**TITLE** Interfata disc flexibil – Circuite formare ceas scriere si PLL digital  
Floppy disk interface – Write clock and digital PLL circuits

FILE: CoBra

TITLE Interfata disc flexibil - Controlorul de disc  
Floppy disk interface - Disk controller

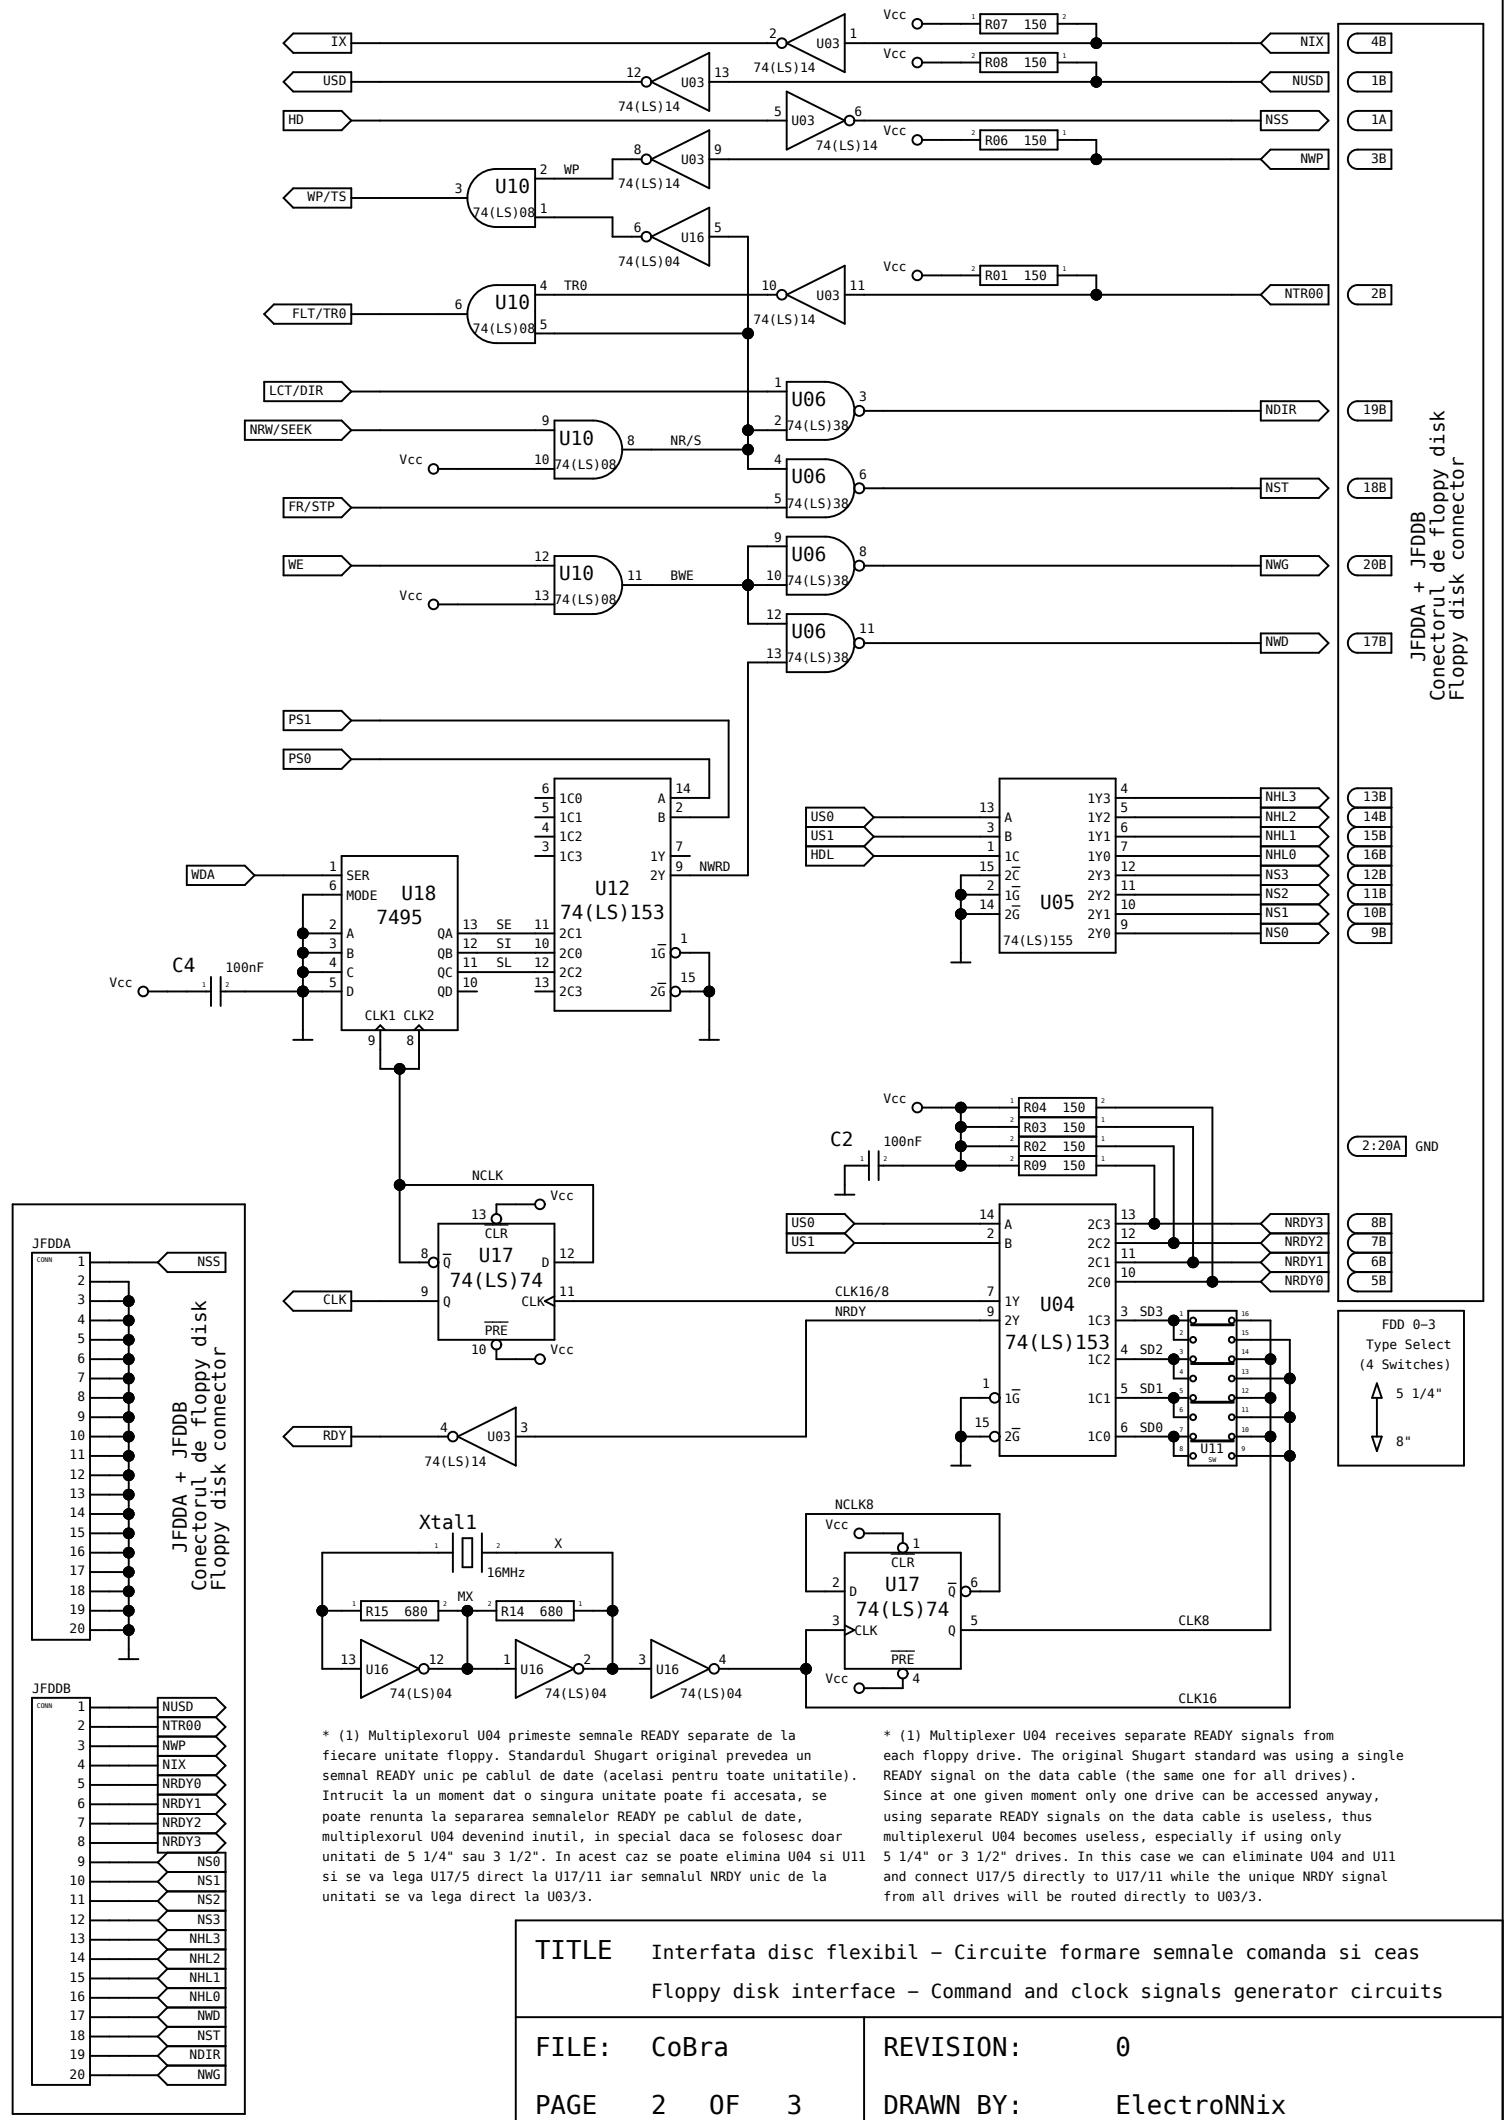
\* (1) In schema originala pinii 1,9,10,11,15 de la U08 erau lasati in aer, doar 4 era legat la "1"

\* (1) In the original schematics pins 1,9,10,11,15 of U08 were not connected, only 4 was at "1"

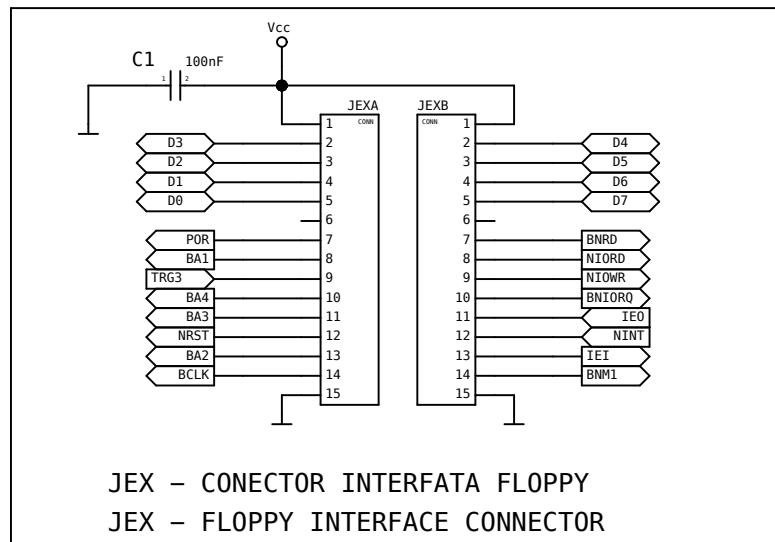
\* (1) Manualul original avea JEXA/8 listat ca fiind legat la BA7. De asemenea cablajul original avea JEXA/8 legat la BA7. Corect este ca JEXA/8 sa fie legat la BA1. Am modificat deci atit schema de fata precum si cablajul legind JEXA/8 la BA1 (pe placă de baza).

\* (1) The original hardware manual had JEXA/8 listed as being connected to BA7. Also the original mainboard layout had JEXA/8 connected to BA7. Correctly, JEXA/8 should be connected to BA1. I have therefore changed this schematic as well as the mainboard layout by connecting JEXA/8 to BA1.
